## QUALITY ASSURANCE -- NON-CONFORMANCE REPORT

**Report No:** NCR-000553

**Component:** 8BW Floor Beam FL2-2 to Bottom Panel

**Reference Description:** Segment 8BW, Linear Indication discovered with the MT after the contractor's NDT testing and acceptance

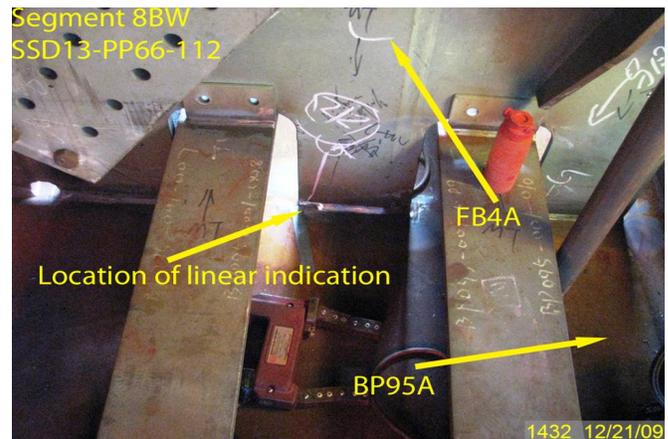
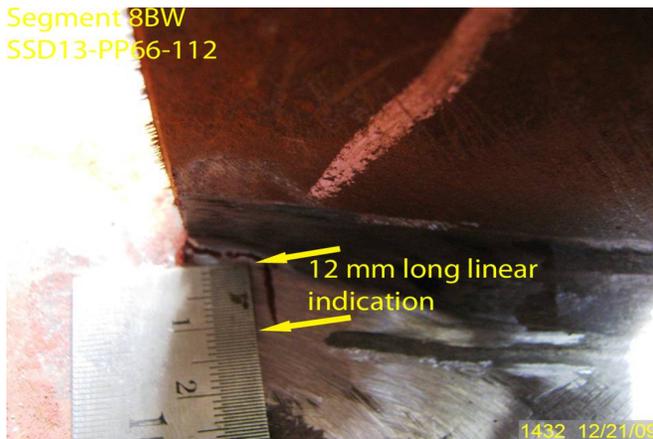
During the Quality Assurance Magnetic Particle Testing (MT) review of welds located on OBG Segment 8BW, this Quality Assurance Inspector (QA) discovered the following issues:

-One (1) Transverse linear indication that measured to be a total of 15mm in length, in the fillet weld joining the FL2-2 floor beam (FB004-027) to bottom panel (BP95A-001) at panel point 66. The weld is designated as SSD13-PP66-112.

The Notice of Witness Inspection Number (NWIT) is 004905. The indication is located inside the area that has been previously tested and accepted by ZPMC Quality Control (QC) personnel.

Special Provisions Section 8.3 – “Quality Control (QC) shall be the responsibility of the Contractor. As a minimum, the Contractor shall perform inspection and testing of each weld joint prior to welding, during welding, and after welding as specified in this section and to ensure that materials and workmanship conform

AWS D1.5 (02) Section 6.26.2 – “Welds that are subject to MT in addition to visual inspection shall have no cracks.

Submit a repair procedure for approval of the engineer. Provide training to the ZPMC MT technician that missed this indication and provide documentation of such training to the engineer. A response for the resolution of this issue is expected within 7 days.

**Component:** 8BW Floor Beam FL2-2 to Bottom Panel

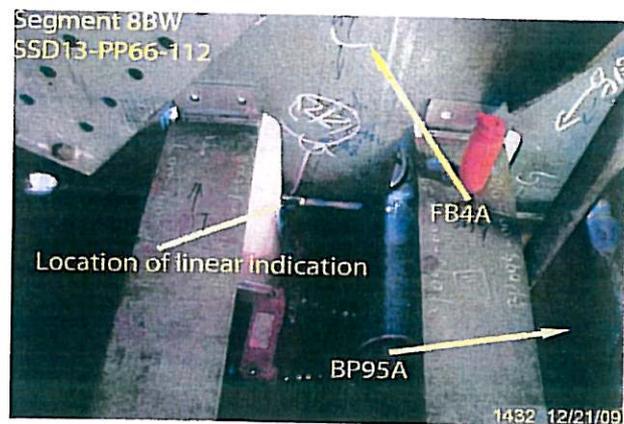
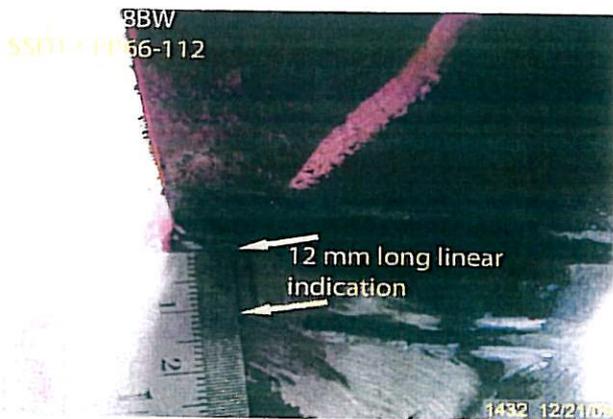
During the Quality Assurance Magnetic Particle Testing (MT) review of welds located on OBG Segment 8BW, this Quality Assurance Inspector (QA) discovered the following issues:

-One (1) Transverse linear indication that measured to be a total of 15mm in length, in the fillet weld joining the FL2-2 floor beam (FB004-027) to bottom panel (BP95A-001) at panel point 66. The weld is designated as SSD13-PP66-112.

The Notice of Witness Inspection Number (NWIT) is 004905. The indication is located inside the area that has been previously tested and accepted by ZPMC Quality Control (QC) personnel.

Special Provisions Section 8.3 – “Quality Control (QC) shall be the responsibility of the Contractor. As a minimum, the Contractor shall perform inspection and testing of each weld joint prior to welding, during welding, and after welding as specified in this section and to ensure that materials and workmanship conform

AWS D1.5 (02) Section 6.26.2 – “Welds that are subject to MT in addition to visual inspection shall have no cracks.

Submit a repair procedure for approval of the engineer. Provide training to the ZPMC MT technician that missed this indication and provide documentation of such training to the engineer. A response for the resolution of this issue is expected within 7 days.

WELD NUMBER: SSD13-PP066-112

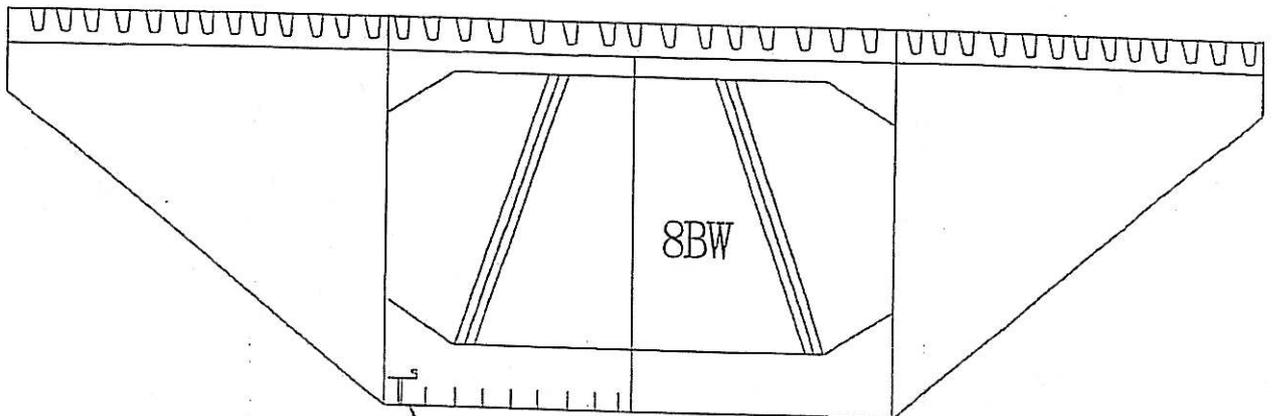
One longitudinal crack was found by use of MT on SSD13-PP066-112.

1. 火焰加热时, 水汽没有完全的去掉或者这个区域预热不够;
1. Moisture wasn't completely removed during drying operation (preheating) or the area wasn't preheated sufficiently.

1. QC and a Lead CWI shall be present, direct and supervise all grinding and welding operations during this repair to ensure the repair is per the disposition requirements

2. QC and a Lead CWI shall have an approved copy of the CWR in hand prior to the repair.
3. Remove paint  $\geq 25$ mm in all direction of HAZ prior to MT.

4. Clean the excavation area of all loose debris including MT powder. Preheat to 65° C before removing cracks by grinding, repair area shall extend a minimum of 50mm beyond each end of single crack repairs.

5. If base metal is damaged by grinding, the damaged area shall be ground clean prior to performing weld repair. If gap  $> 5$ mm is found during or after grinding, comply with the notification on changing fillet weld to CJP which is submitted for Engineer's review and approval form.

6. Prepare excavation in accordance with the New Repair Procedure prior to welding.
7. Before this repair, Verify with VT and MT repair areas are defects free, and also MT shall be performed on the base metal laying abroad cracks to ensure that no cracks were propagated to the base metal. Separate CWR approval is needed if cracks are found in the base metal, and only after this new CWR's approval can continue the repair.

8. Clean excavation area of all loose debris including MT powder after excavation. Preheat and weld according to repair WPS, the preheat shall between 160° C-230° C.

9. Perform post weld heating according to repair WPS, the postheat shall between 230° C-315° C and for one hour minimum.
10. Allow the weld to cool to ambient temperature gradually. Control cooling rate after PWHT to no more than 50° C per hour.

11. Grind the repaired area flush with base metal or the adjacent weld after post weld heating.
12. Wait 48 hours at least after the repair area has cooled to ambient temperature before performing NDT.

13. Perform MT inspection to all repair area according to Contract Drawings along with all additional NDT required by the applicable notes Special Provision Section 10-1.59 'Steel Structure', subsection 'inspection testing'. NDT include VT, MT and UT if it is a CJP weld.
